APPEAL SUMMARY

Status: Decision Rendered - Reconsideration of ID 20378

| Appeal ID: 20394 | Project Address: 736 SE Ankeny St |
| Building/Business Name: Ironside Fitness | Fire Sprinklers: No |

A101

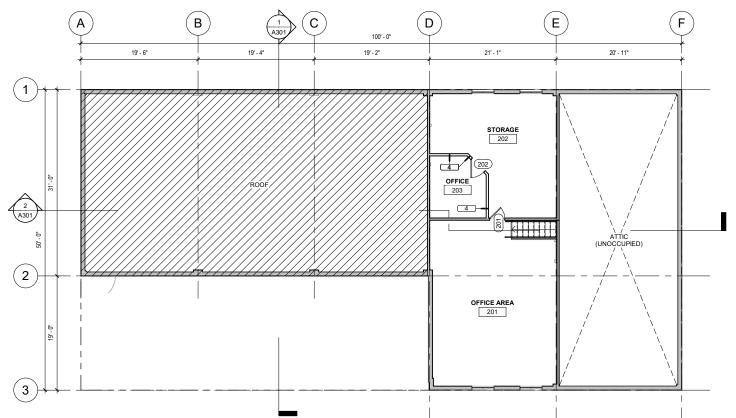
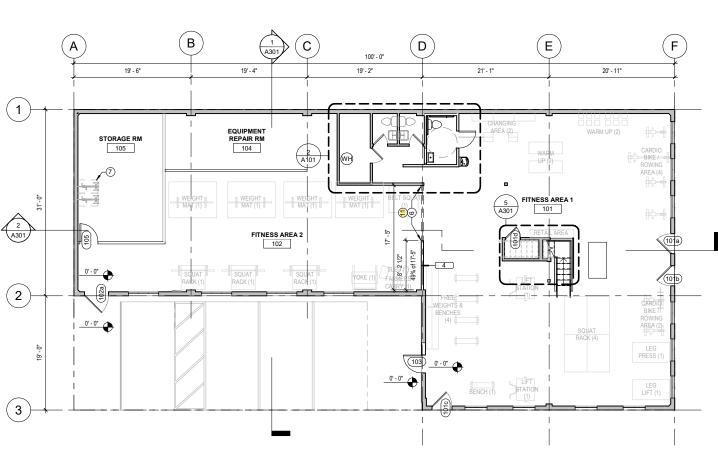
We received comments that the Fitness Area 2 exit path had congestion due to the bicycle storage and the lack of a door on the storage room in this area as previously shown. Therefore, plans have been updated to clear this exit path in the following ways:

- 1-Moved bikes into Storage Room
- 2-Added a door to Storage Room for separation of uses

Additionally, a smoke draft curtain was requested to be added to the plans at the connection of the Double B spaces. This has been added. A101, keynote 11.

Side by side B occupancies: Granted for this tenant and configuration provided a draft curtain is installed above the opening between the two rooms, extending a minimum of 24" below the ceiling height of both rooms.
